Photo Report

Brand Park

Finding: Brand Park, located at 1601 West Mountain in Glendale California, was inspected by Disability Access Consultants, Inc., on June 8, 2007.

Curb Ramp Outside of the Tea House

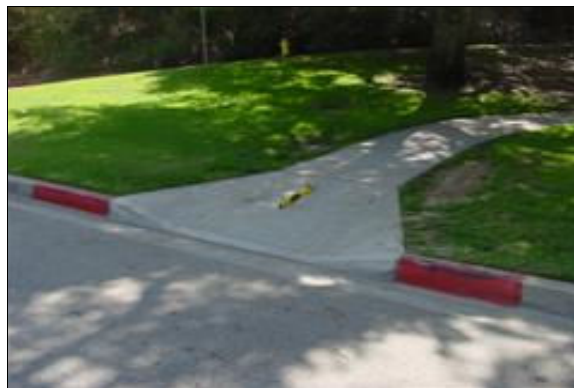
Finding: The slope at the bottom landing is greater than 2%. The curb ramp does not provide a grooved border along the top and sides of the ramp at the level of the sidewalk. The concrete curb ramp does not provide a detectable warning surface which includes truncated domes.

Full Rec: Replace the curb ramp with a compliant curb ramp at least 48 inches in width that provides a slope no greater than 8.33%. Install a detectable warning surface which extends the full length and width of the concrete curb ramp and its side flares with truncated domes that contrast visually by either light on dark or dark on light which is an integral part of the concrete curb ramp. The truncated domes may be cast in place or stamped or of a prefabricated surface treatment (see CBC 1127B.5.8).

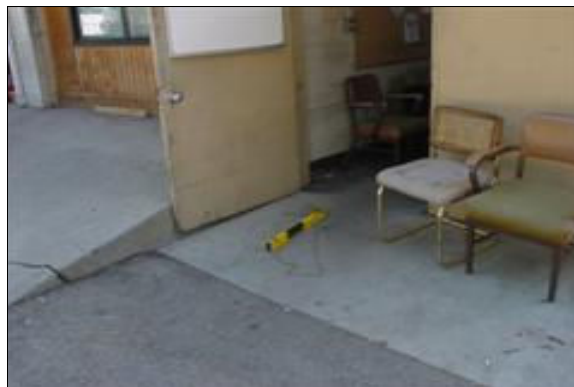
Finding: There is no level landing provided at the entrance door.

Full Rec: Provide a level and clear landing at least 60 inches in length in the direction of the door swing.
